T.I. no.: 2019 - 30 Updated: -	Topic: Schaerer Barista – Software version 2.2.2
---	---

Date: 12.12.2019
Affected machines: Schaerer Barista
From serial number: -
As of date: -

Display portafilter removal

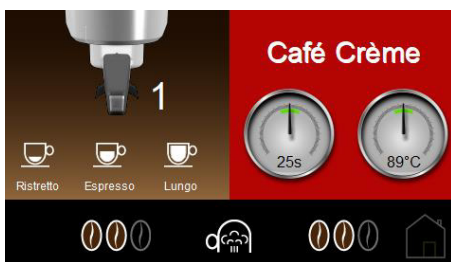
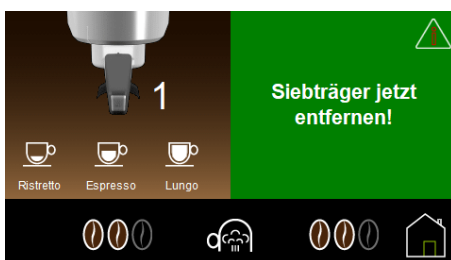
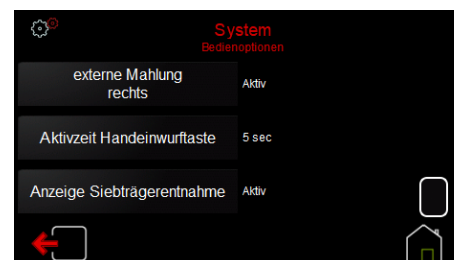
We are still getting reports from the field stating that users are removing the portafilter too soon after beverage dispensing and this is resulting in avoidable service visits.

In order to provide users with an extra visual aid in addition to the existing warning tone, this software makes it possible to use background colours in the display to tell the user when it is time to remove the portafilter.

Menu navigation: System > Control options > Display portafilter removal
